AMBIT ENGINEERING, INC. CIVIL ENGINEERS AND LAND SURVEYORS

RE: Request for TAC Site Plan Approval at 41 Salem Street, Tax Map 144 / Lot 31

The project received a Technical Advisory Committee recommendation of approval at the April 13, 2020 Technical Advisory Committee Meeting subject to stipulations. The stipulations, as well as our responses to the stipulations, are listed below:

PROPOSED RESIDENTIAL DEVELOPMENT 41 SALEM STREET PORTSMOUTH, NEW HAMPSHIRE PERMIT PLANS

**SALEM STREET
 PLAN AND PROFILE**

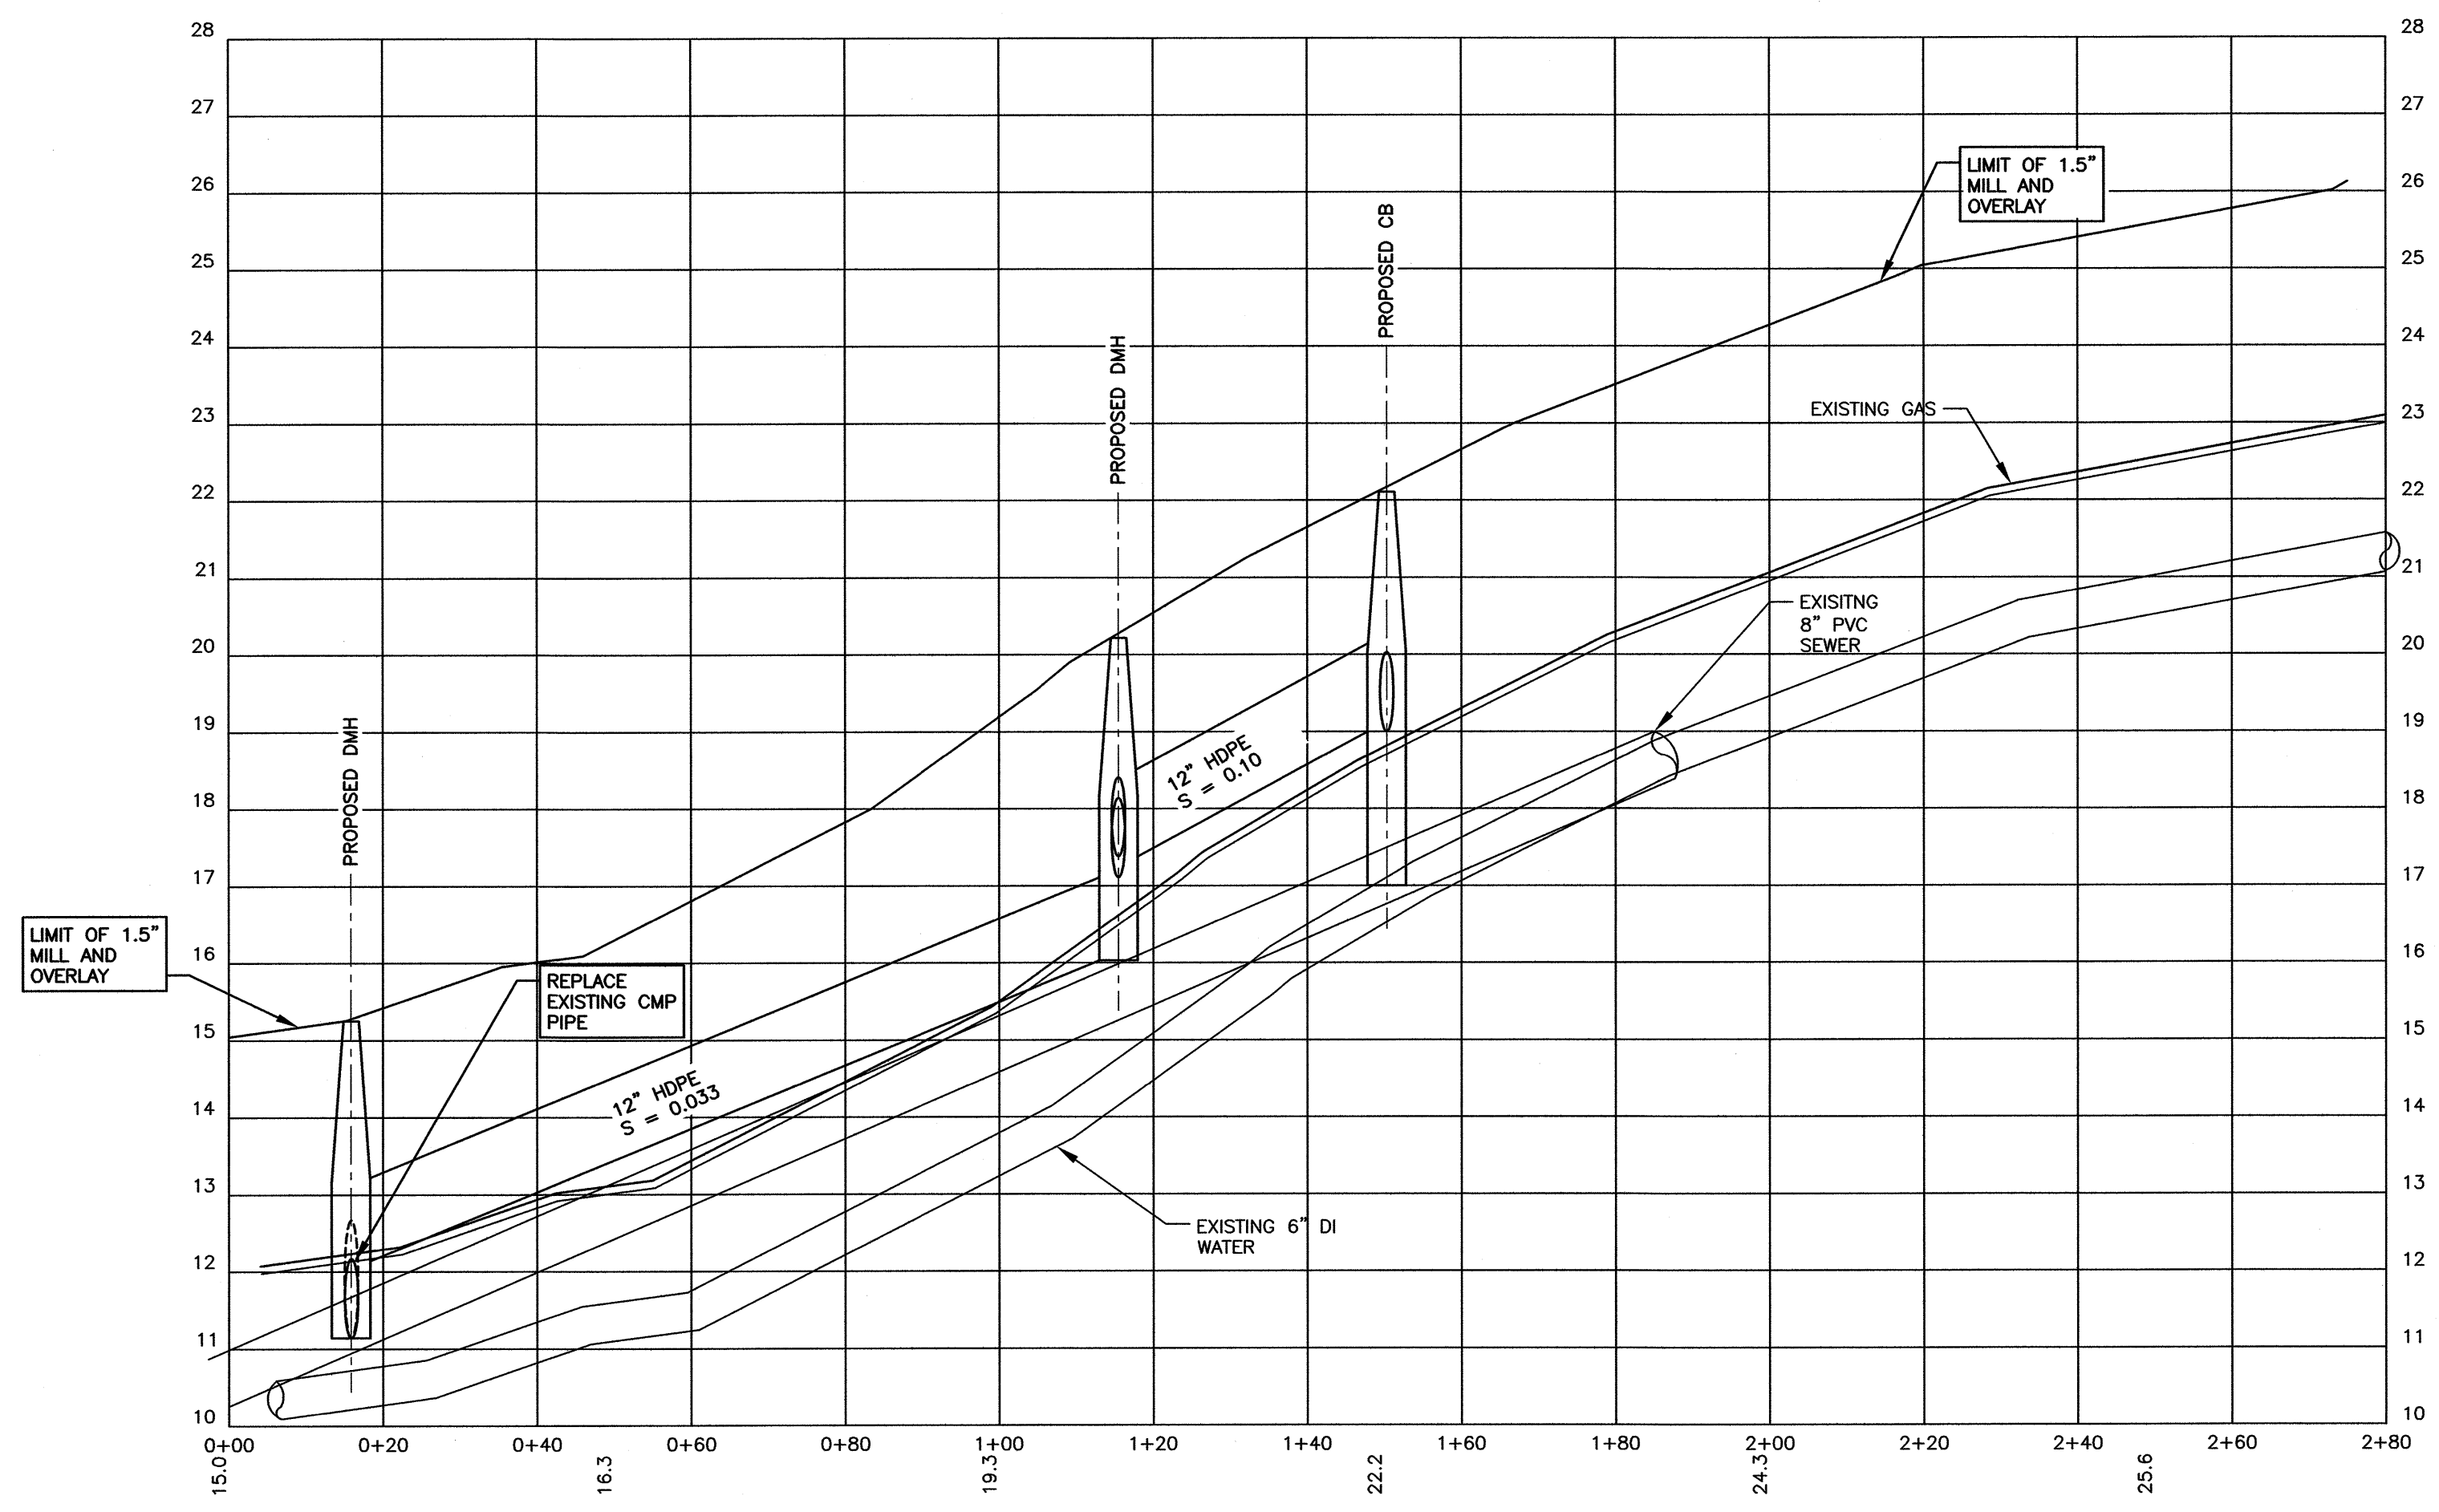
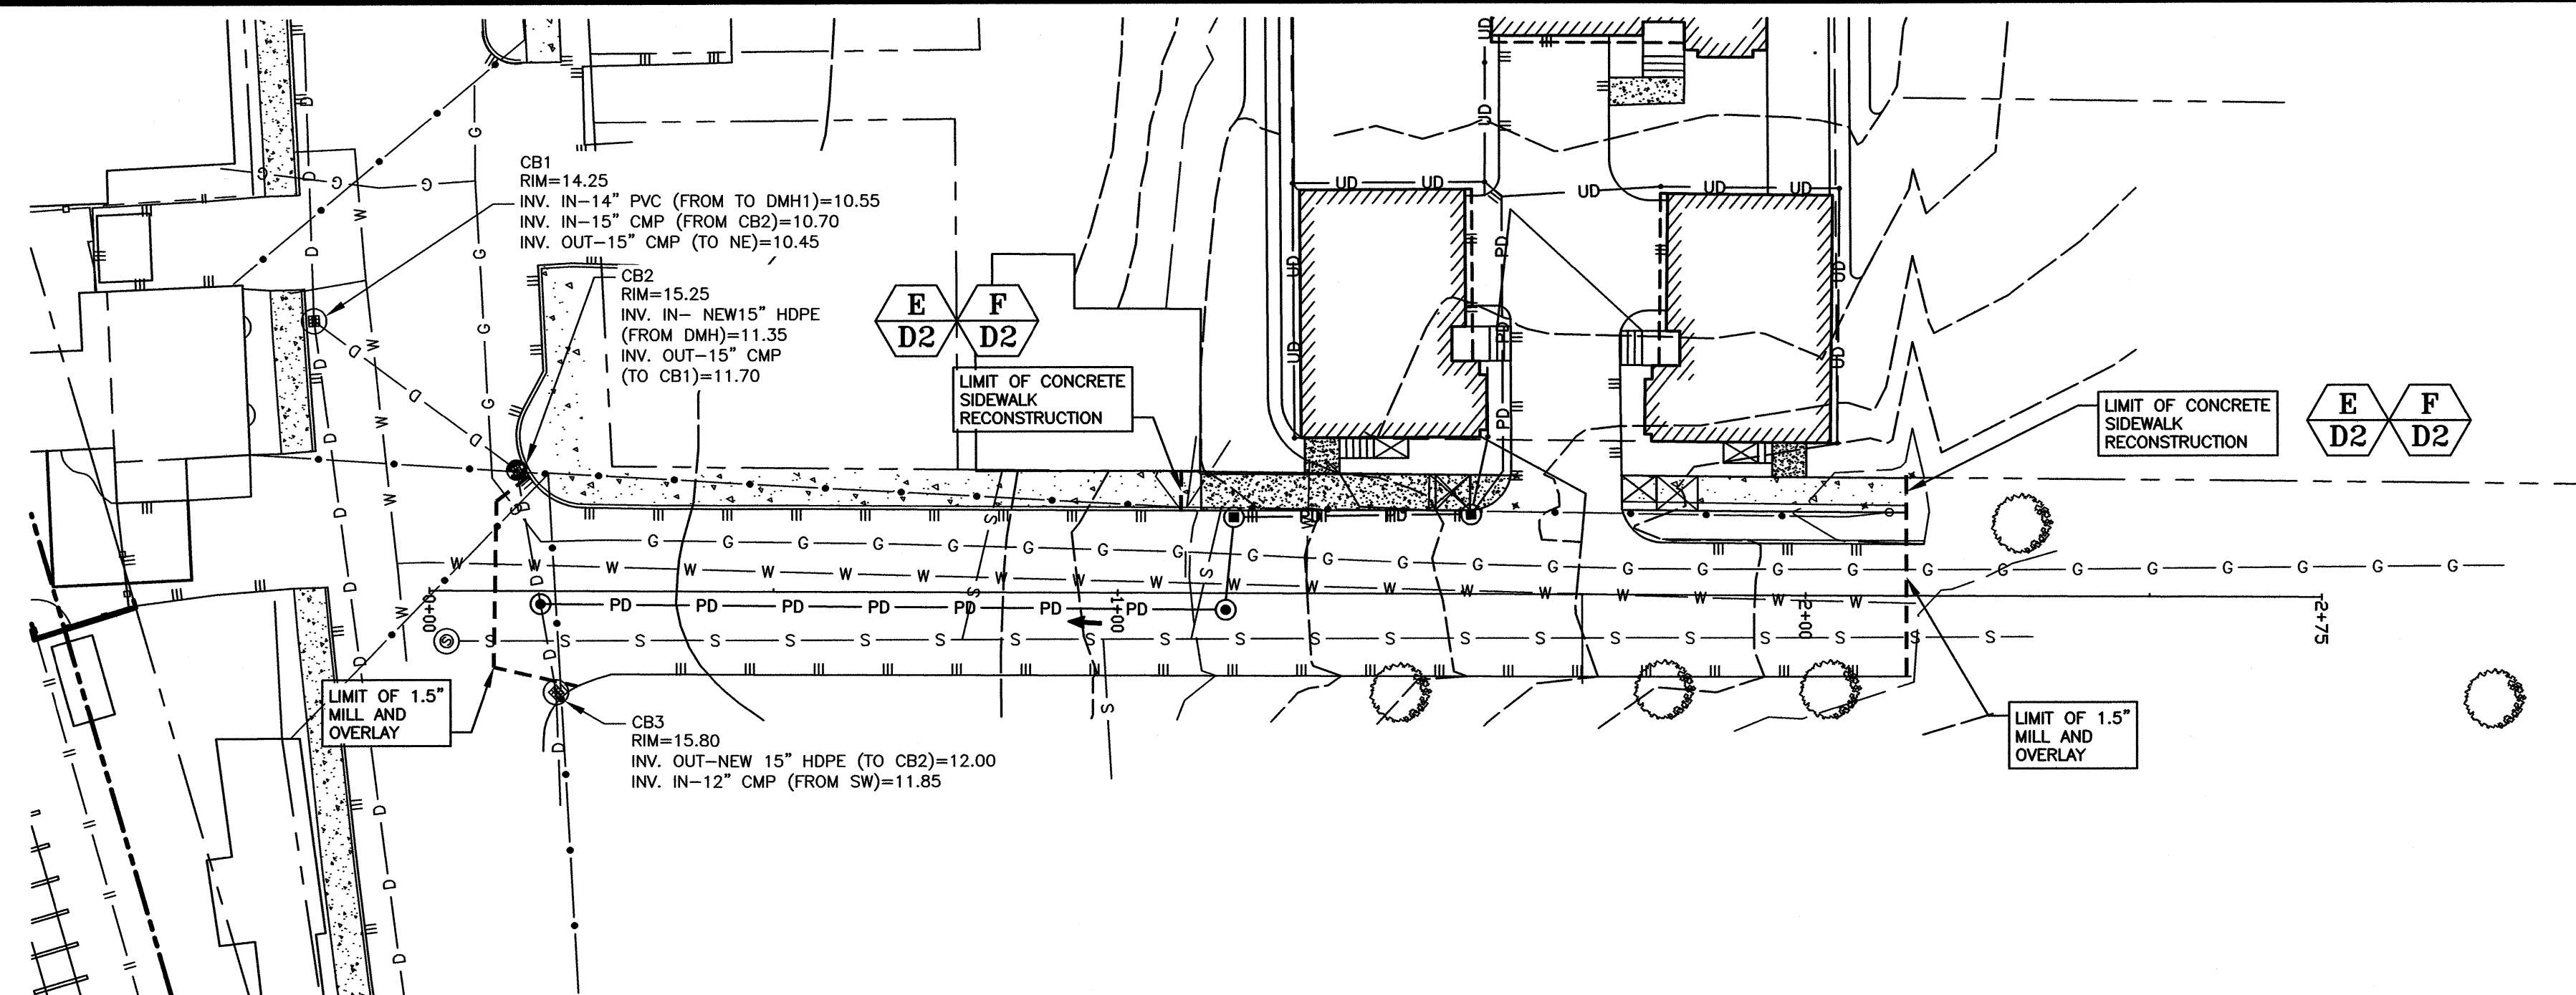
- j. Replace drain pipe from CB2 to CB3 with new 15" PE pipe at intersection of McDonough and Salem; **This is shown on Sheet P1.**
 - k. New drain pipe in Salem Street should be sized at 12"; **This is shown on Sheet P1.**

- p. On profile view: a) Raise proposed drain main in Salem Street so it is not in conflict with sewer; b) Existing 6" DI water is likely shallower than depicted; c) Gas main is likely shallower than depicted, to be confirmed with DPW. **This is shown on Sheet P1.**

J DRAIN MANHOLE DETAIL NTS

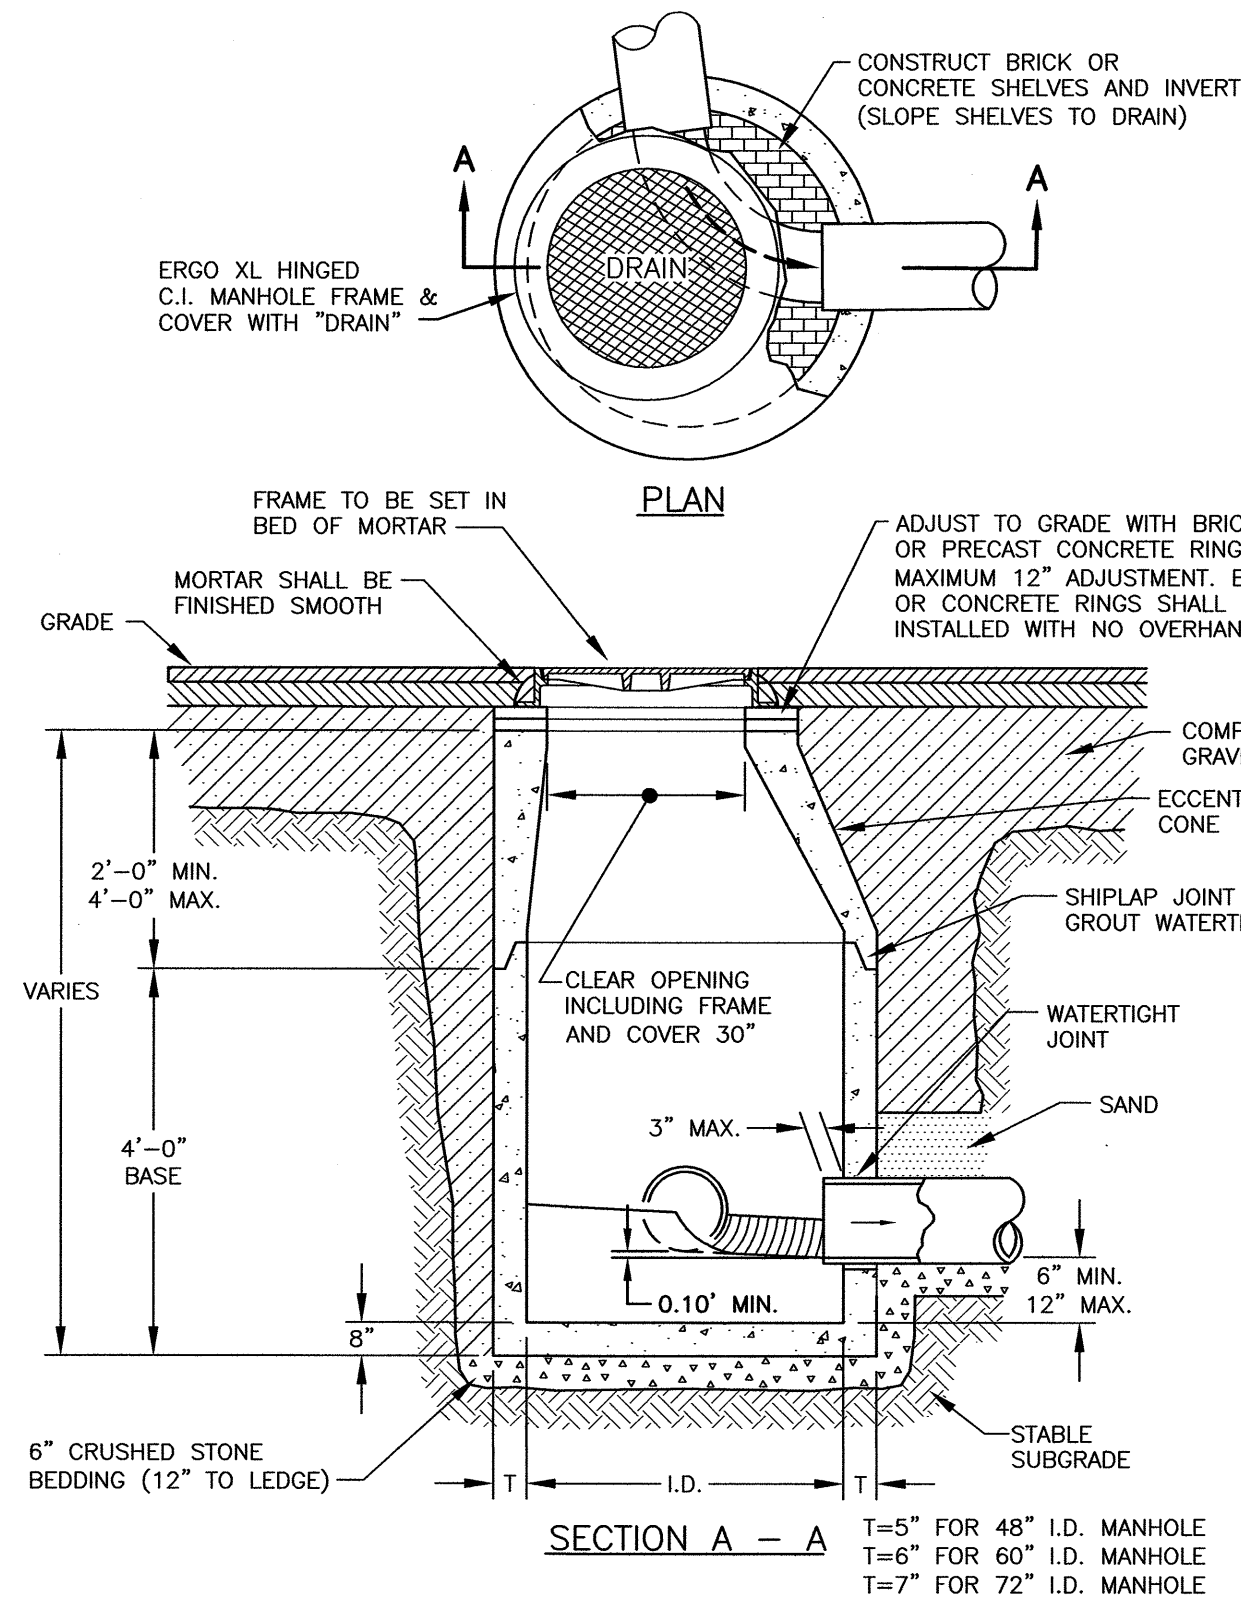
- n. Use Ergo XL hinged cover marked "Drain" for DMH(s); **This is shown on Sheet D2, Detail J.**
 - o. Provide sewer service details showing 6" PVC services with wyes cut into main and patched back in with pvc repair couplings (no rubber 'Fernco' couplings allowed); **This is shown on Sheet C3, Detail 1.**
